SUBJECT: APPLICATION FOR THE WESTINGHOUSE SENTRY™ DRY STORAGE CASK SYSTEM, CERTIFICATE OF COMPLIANCE NO. 1026, AMENDMENT NO. 5 – REQUEST FOR ADDITIONAL INFORMATION (EPID L-2020-LLA-0105)

Request for Additional Information
Docket No. 72-1026
SENTRY™ Dry Storage System
Certificate of Compliance No. 1026
Set 1

Chapter 4: Structural Analysis

Figure 4.6-50 - SENTRY W180 Storage Cask Concrete Effective Plastic Strain during End Drop Event - Inner View

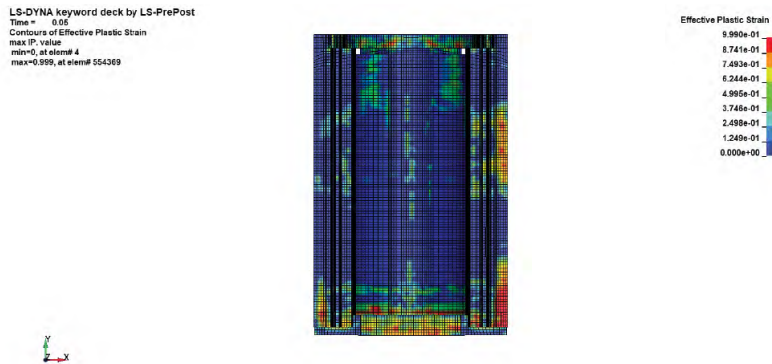
SAR Section 4.6.5.6.2 discusses the structural evaluation of the storage cask after an end drop and further refers to Figures 4.6-50 through 4.6-54 for additional results. The staff requests the following:

- b. SAR Figures 4.6-50 and 4.6-51 show the resulting concrete effective plastic strains during an end drop event. The staff noted that given that this is a one-half symmetry FEM that is vertically striking the target, the resulting plastic strains should behave in a similar symmetric manner. The aforementioned figures show some areas of possible antisymmetry in the response. These could be caused by a number of reasons including possible contact discrepancies between elements. Justify these apparent discrepancies.
